SAN ANTONIO WATER SYSTEM
San Antonio River Outfall Pipeline Project No. 2B
SAWS Job No. 13-4510 (Sewer)
Solicitation No. CO-00017

ADDENDUM NO. 1
September 9, 2015

SAWS JOB NO. 13-4510 (SS)
 SAN ANTONIO RIVER OUTFALL PIPELINE,
 PROJECT NO. 2B
 LINE 'C' PLAN AND PROFILE
 STA. 153+00 TO STA. 162+00

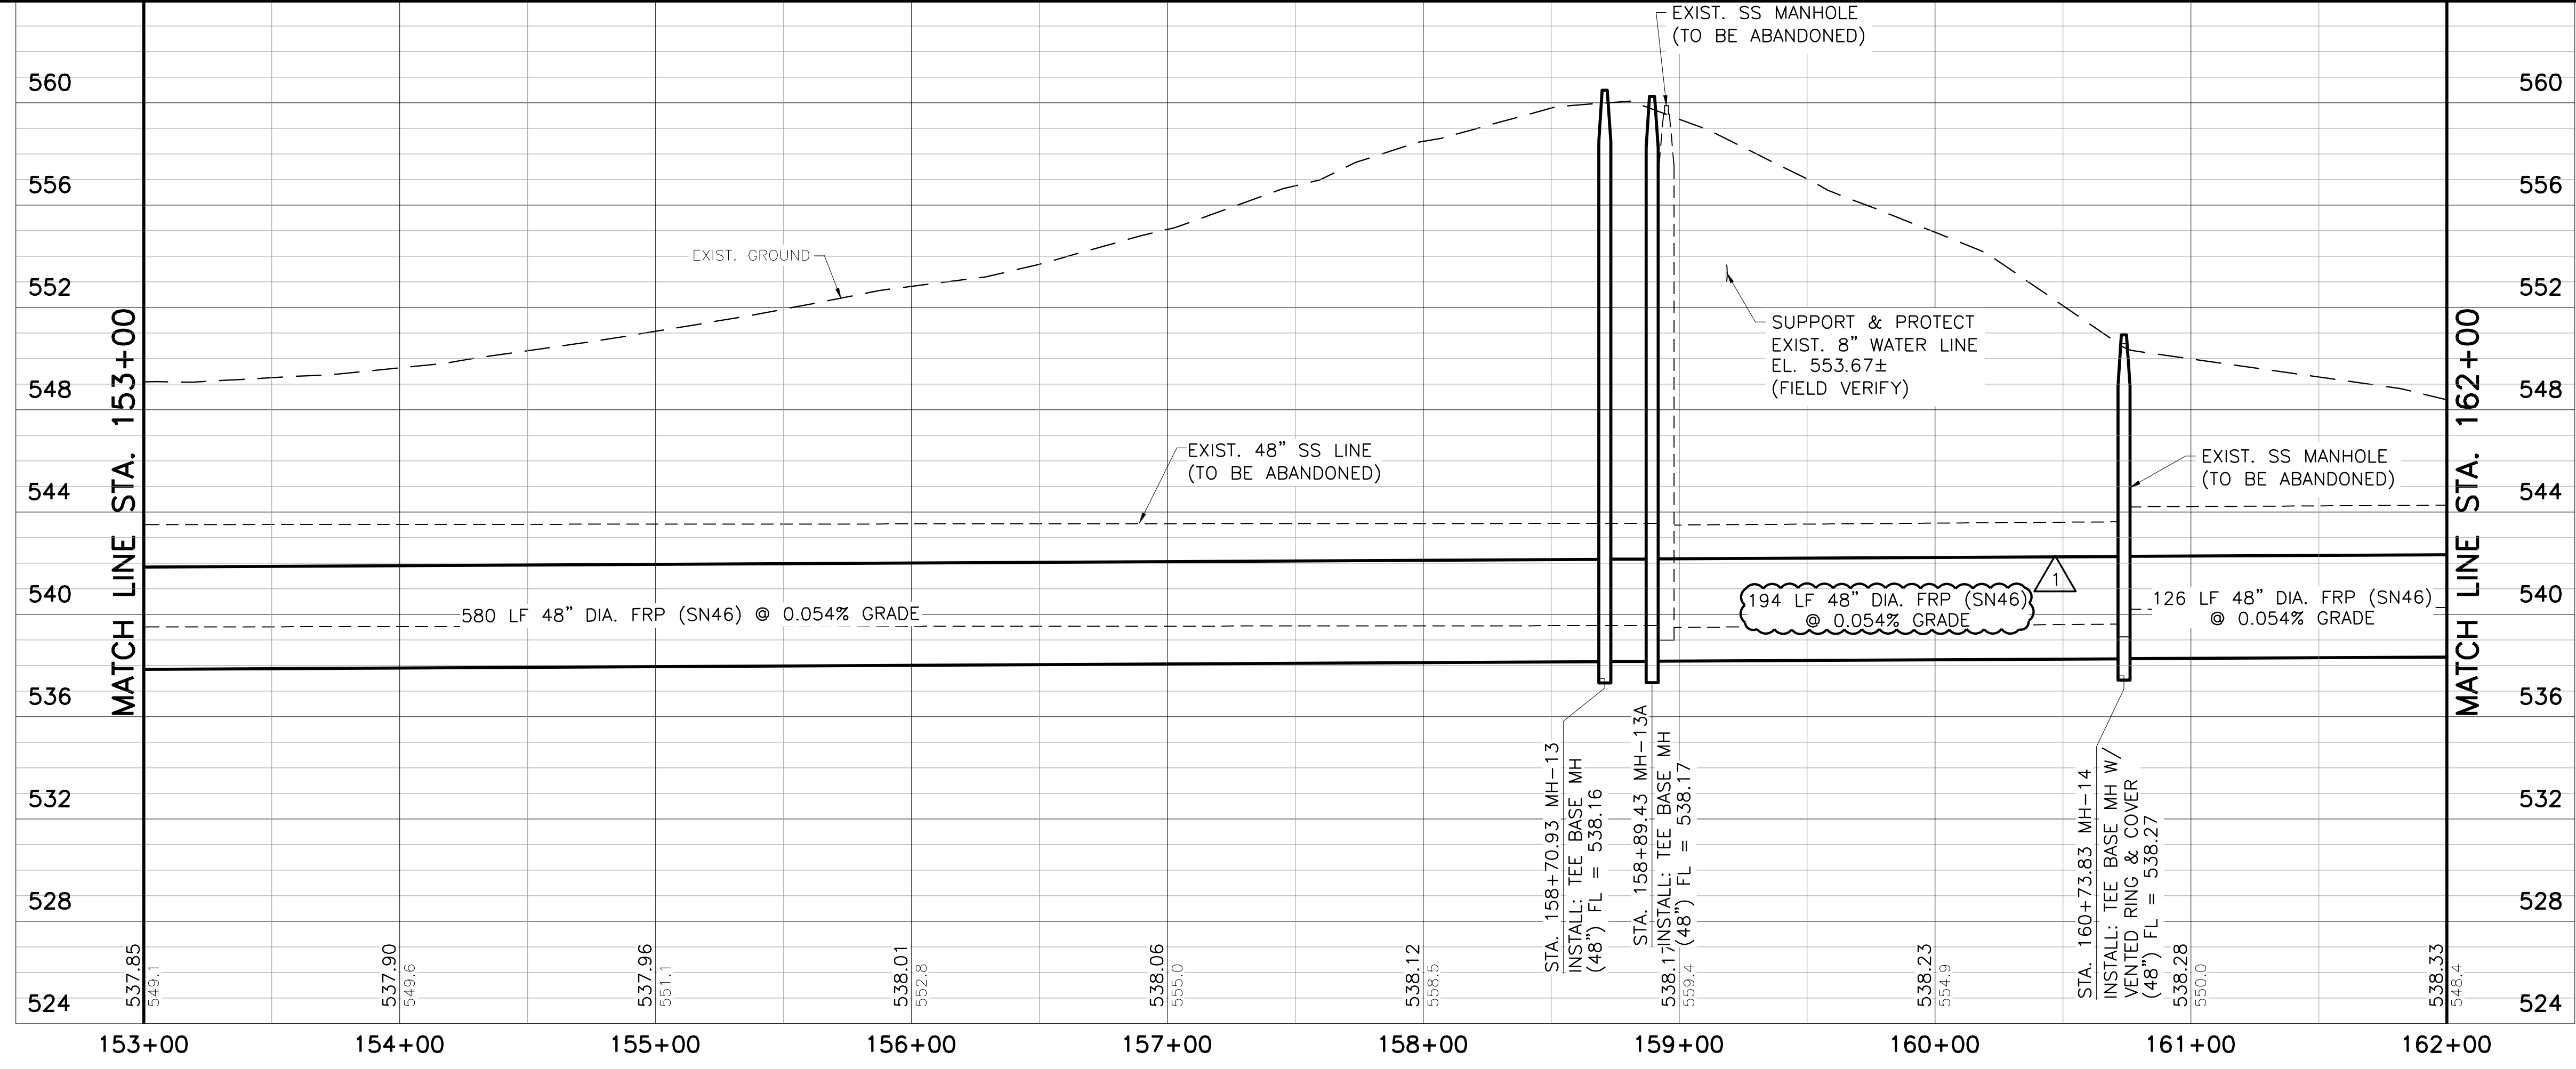
3. **Question:** Can you please clarify the required DN48 pipe stiffness for the pipe detailed on sheet PL4 between MH-13 and MH-14. A pipe stiffness of SN72 is called out for the pipe in the profile view, however only a pipe stiffness of SN46 is shown in the bid quantities table on this page. There is similar conflicting information on sheet PL9 that requires clarification, for the pipe required between MH-21 and MH-22.

3. **Answer:** The quantities table is correct. The pipe stiffness class was mislabeled on the sheet profiles. See Addendum No. 1, Part 3, Item Nos. 2 and 3.

SAWS JOB NO. 13-4510 (SS)
SAN ANTONIO RIVER OUTFALL PIPELINE,
PROJECT NO. 2B
LINE 'C' PLAN AND PROFILE
STA. 200+00 TO STA. 210+00

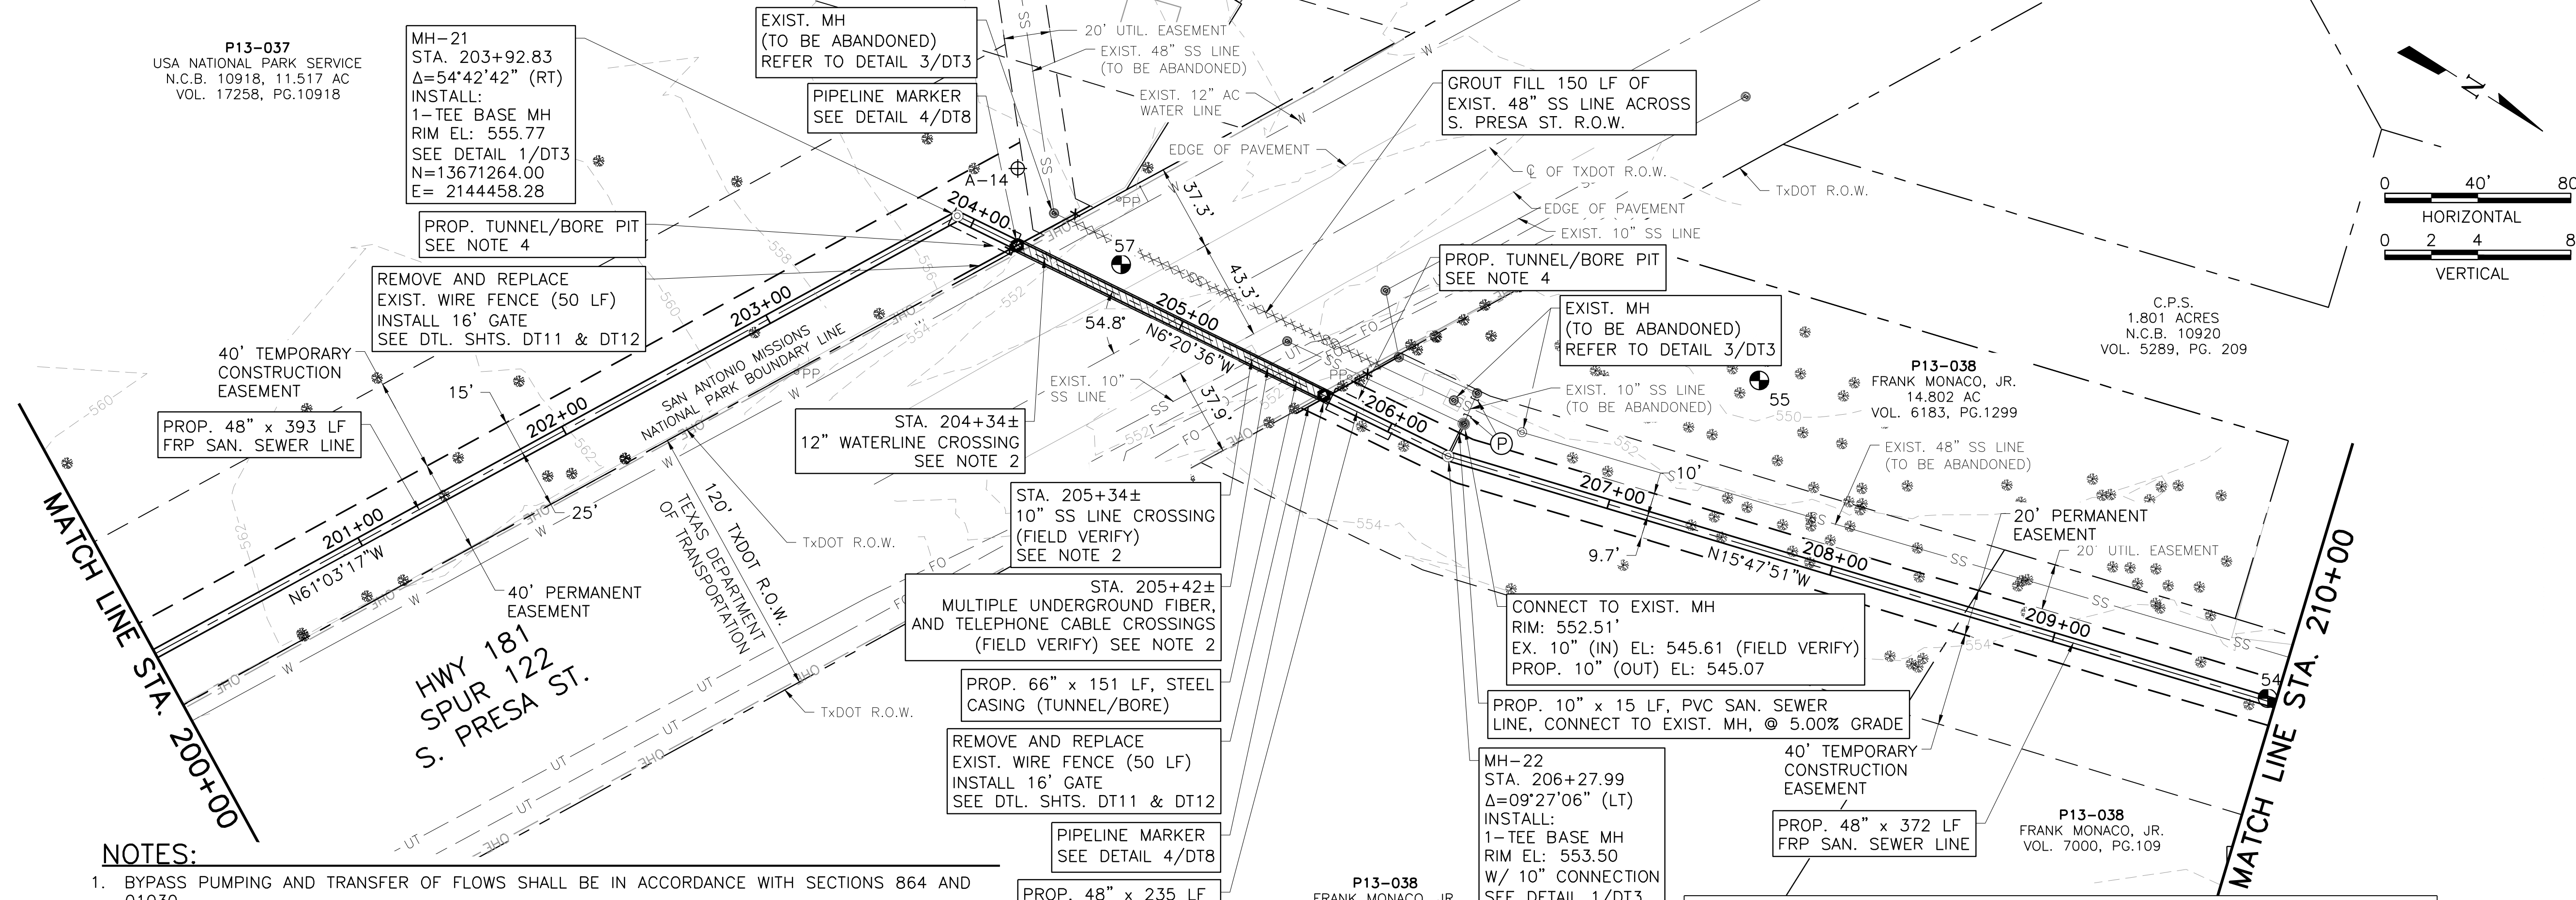
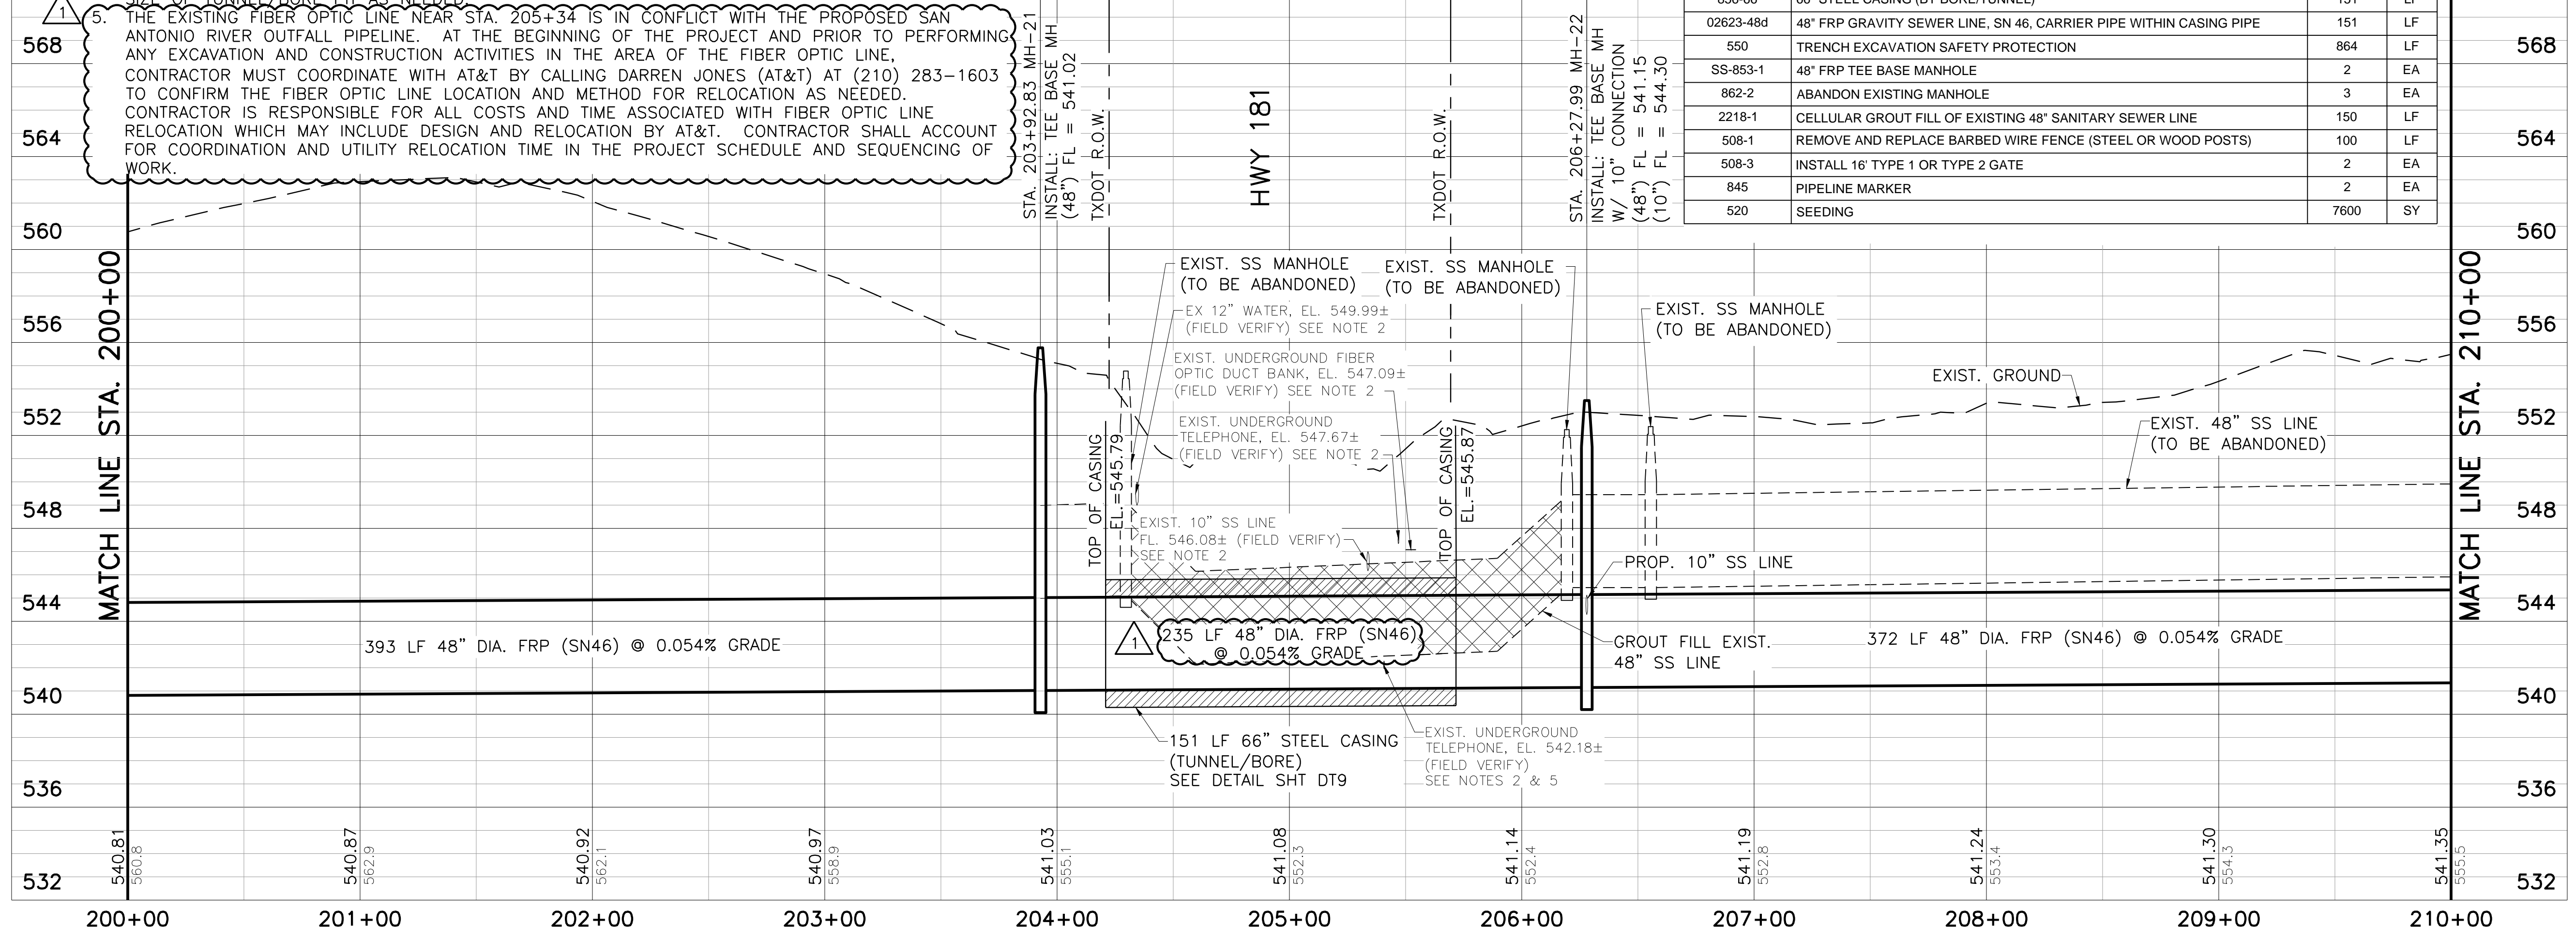
13. **Answer:** We are not providing an excel format of the bid proposal. Please use the form within the bid document.
14. **Question:** Can SAWS provide a working phone number for AT&T because the number listed on note 5 in plan sheet PL9 is not a working number.

14. **Answer:** See Addendum No. 1, Part 1, No. 1 and Addendum No. 1, Part 3, Item Nos. 1 and 3.
15. **Question:** If AT&T cannot provide a cost for relocations, design and time impact associated with fiber optic line relocation before bid time, how much time/money should contractors account for in their bid for that work?

4 - FRP TEE BASE DROP MANHOLE
NOT TO SCALE

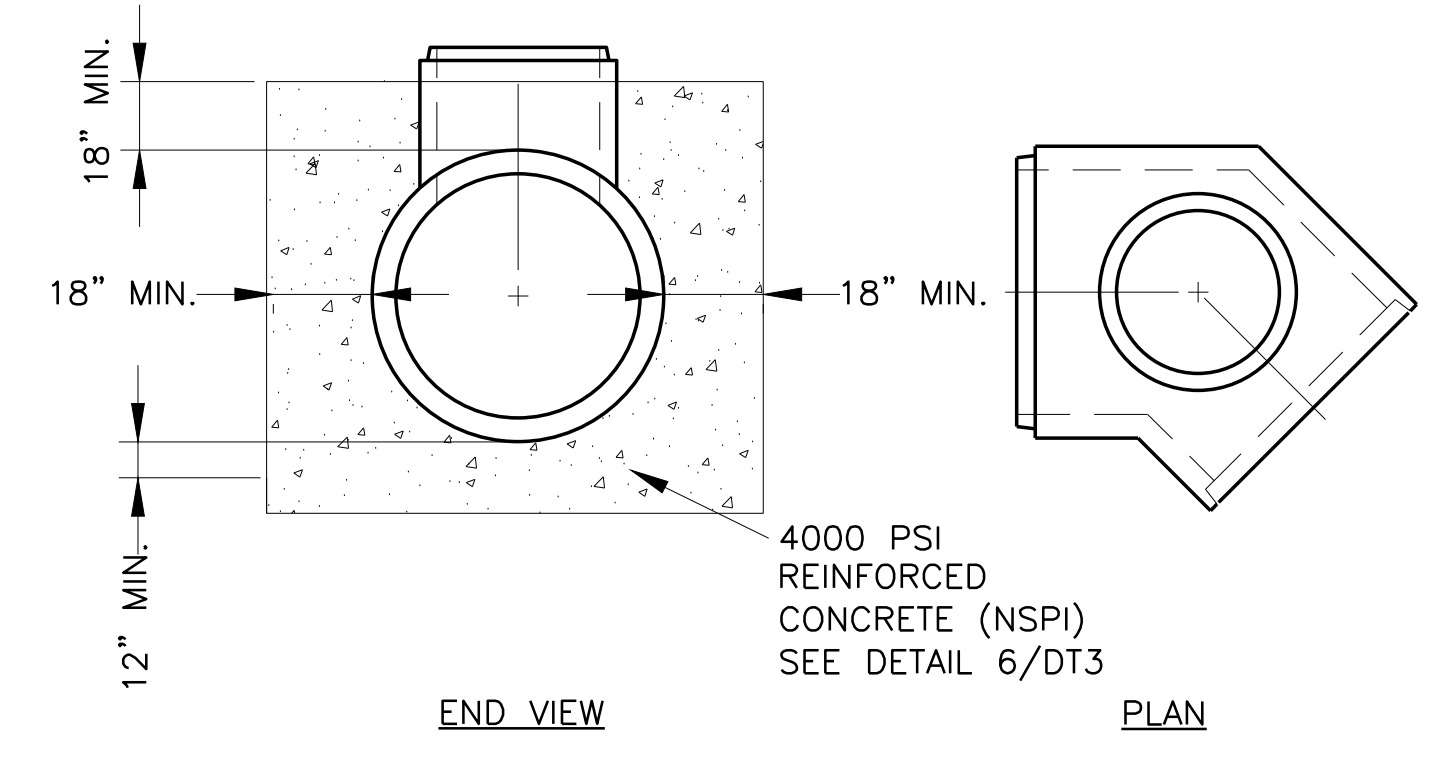
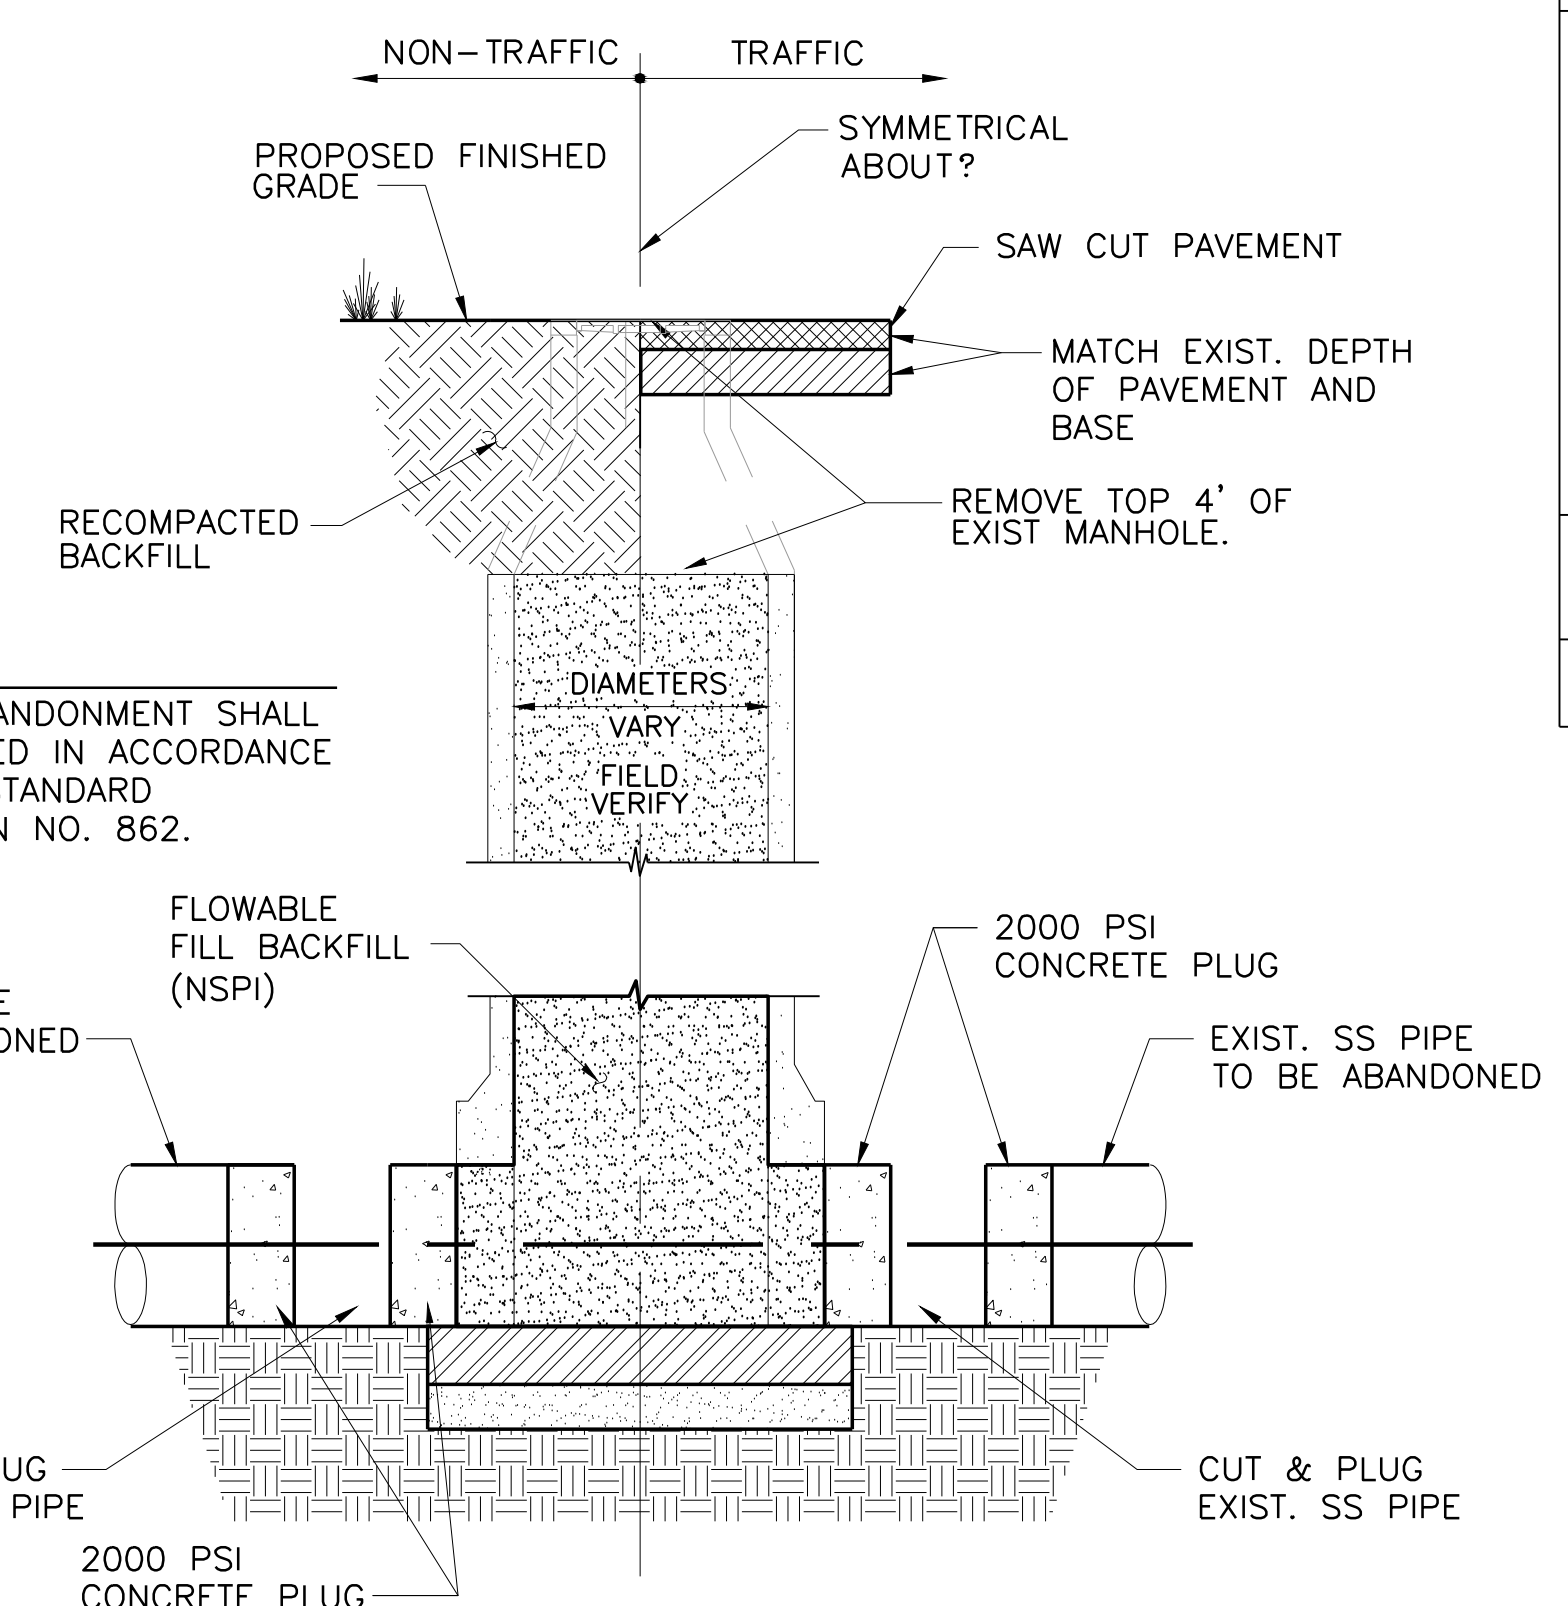
9. **Question:** Detail 4 and 5 of sheet DT-3 call for lateral out of tee base to be FRP material for connection to PVC. Standard Tee base manholes are built with PVC (SDR 26) pipe as laterals. **Please confirm lateral stub out built on tee base to be PVC pipe.**

9. **Answer:** Outlets shall be PVC (SDR 26). See Addendum No. 1, Part 3, Item No. 4.
